Revised Project Concept Report

Revised Project Concept Report

Project Number: BHF-001-6(43)

**SR 2 /US 41 OVER
SOUTH CHICKAMAUGA CREEK
PROJECT NO. BHF-001-6(43)
P.I. NO. 631505
CATOOSA CO.**

TYPICAL SECTION

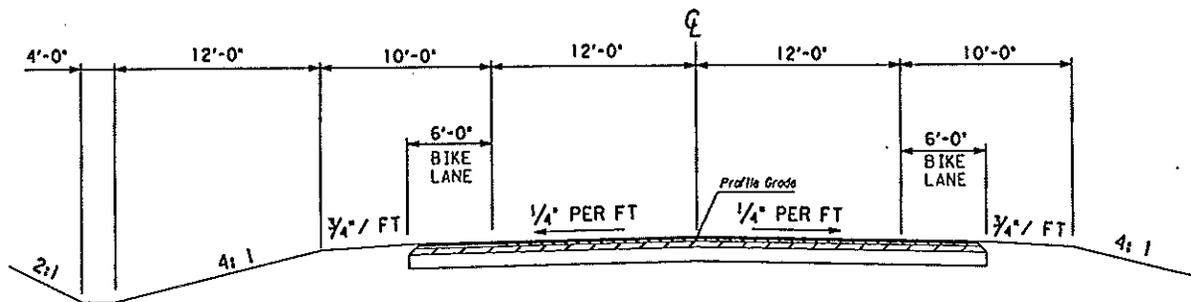
- 1) *The revised bridge will be widened to the high side of superelevation for a total width of 48 feet. The proposed bridge section will consist of two 12 foot lanes, two 6 foot bike lanes (includes 2 foot gutter for each bike lane) and two 6 foot sidewalks. The existing bridge deck will be replaced. The existing substructure and superstructure will be retained. The existing low beam elevation will provide 0.42 feet of free board (1.00 ft. min.) above 100 year storm; however, this alternate will provide the most economical and functional bridge. The centerline of the proposed bridge will shift approximately 8 feet from the existing centerline.*
- 2) *The proposed two lane alignment will tie-in 360 feet north the bridge and 460 feet south of the bridge. The revised gross length of the project is 0.22 miles.*
- 3) *This project will be prepared in English units.*
